CNRO-2004-00026

SUBJECT: Request for Alternative ANO1-R&R-006 -
Proposed Alternative to ASME Weld Examination Requirements for
Repairs Performed on Reactor Vessel Head Penetration Nozzles

Arkansas Nuclear One, Unit 1
Docket No. 50-313
License No. DPR-51

**RESPONSE TO NRC REQUEST FOR ADDITIONAL INFORMATION
(REVISED 4/30/04)**

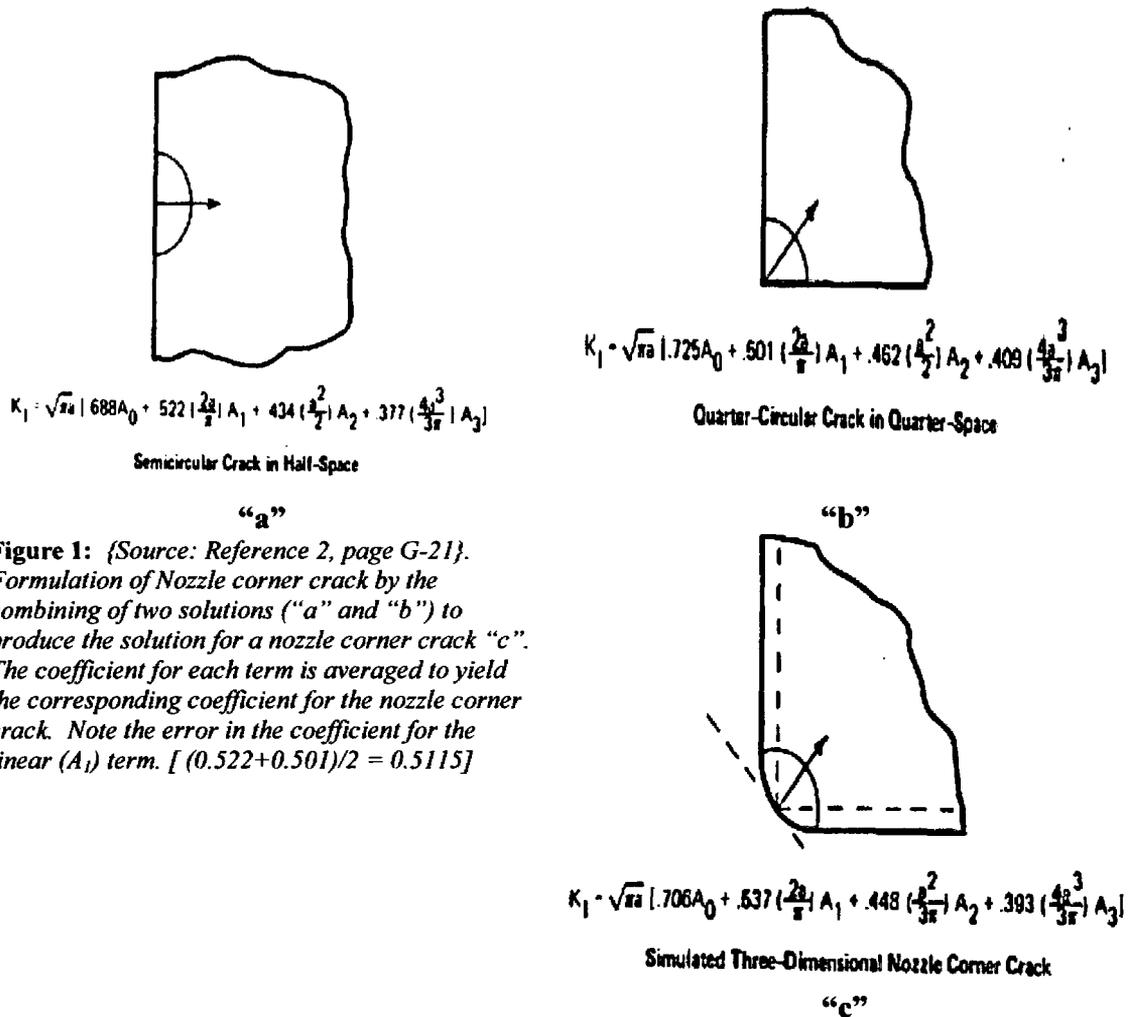
Concern 1: The stress intensity factor (SIF) equation, used in the analysis of the J-groove weld flaw, in Reference 1 was obtained from Reference 2. The formulation, Figure 1, was a combination of two influence function solutions. The two solutions used to derive a solution [2] for the corner flaw in a nozzle were:

- a) A semi-circular crack on a half-space (upper left in Figure 1); and,
- b) A quarter-circular crack in a quarter-space (upper right in Figure 1).

The derivation for the corner crack for a nozzle consisted of averaging the coefficients from the two equations for the two other crack models described above. The coefficients for the nozzle corner flaw are shown in the lower right sketch of Figure 1. The averaging of the two coefficients for the linear term (A_1) appears to be in error. The average of the coefficients from the two base models results in a value of 0.511 for the resulting coefficient, whereas the value in the equation is 0.537.

The publication, cited in Reference 2, was published at the request of the ASME Nuclear Codes and Standards Department to provide the information to utility members. The foreword to this publication clearly states that; "*The solutions provided herein are for information only*". Furthermore, the reference cited for this formulation is a personal communication between two individuals. There is no cited reference that provides an analytical basis for the formulation.

Contrary to the basis of the analytical method (influence function/weight function) that required the stress distribution in the cracked region be considered, the justification provided in Reference 1, and cited above, ignores the contribution from residual stress distribution. Therefore, the assumption made in Reference 1 violates the basis of the method.
